ST PAUL'S CATHEDRAL: HEARING STATEMENT ADDENDUM
MAIN MATTER 7 – HERITAGE AND TALL BUILDINGS

This addendum to the Statement of MM7 has been prepared on behalf of the Dean and Chapter of St Paul's Cathedral.

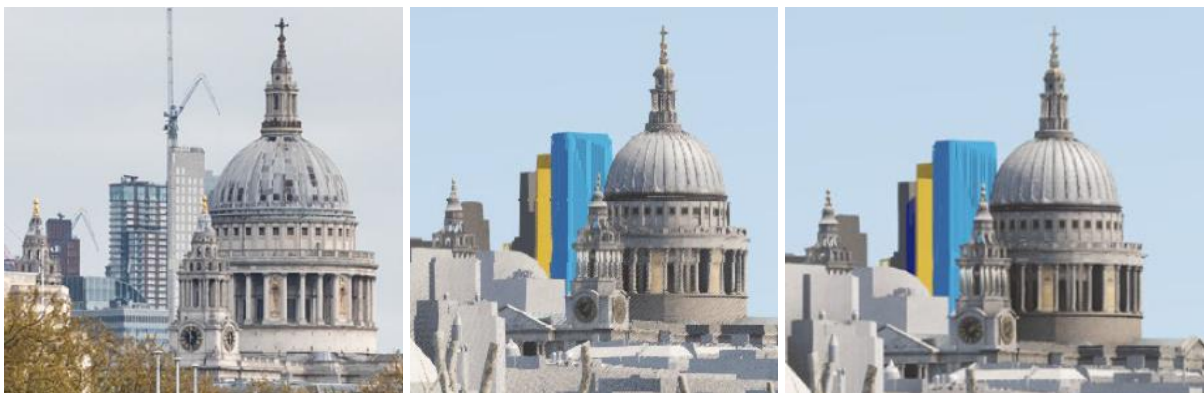
We first note that the buildings within this baseline are harmful to the heritage significance of the Cathedral, both individually and collectively. They erode the Cathedral's silhouette and also visually compete with the Drum, Peristyle, and Dome. Some of these buildings lie beyond the boundary of the City. This heritage harm is most apparent outside of strategic views, though this does not undermine the level of heritage impact. We hope the Inspectors will agree that the existing situation is harmful and detracting, as this is unambiguous.

The new site effectively 'shadows' these tall buildings and would consolidate this group. We agree with the City's statements that the proposed site does not add additional overall height or overall width to this grouping of harmful buildings.

However, we consider that any future building constructed within the parameters of the contours, and thus supported by planning policy, has the potential to entrench and perhaps deepen the existing harm in the short and long term. We seek to know more about how this harm would be absolutely prevented through policy.

As appreciable in New View 2, any proposal within these contours would appear in front of the Broadgate Tower. Such a proposal would be closer to the viewer, more resolved or more distinct in

the view, and thus potentially worsening the current harm evident from this building (as found from our experiences of previous consents such as 55 Old Broad Street). Overall, the principle of new buildings in this location therefore have the potential to increase the presence of this harmful group within the view, exacerbating harm. There would be a similar, although lesser, compounding impact in New View 3.
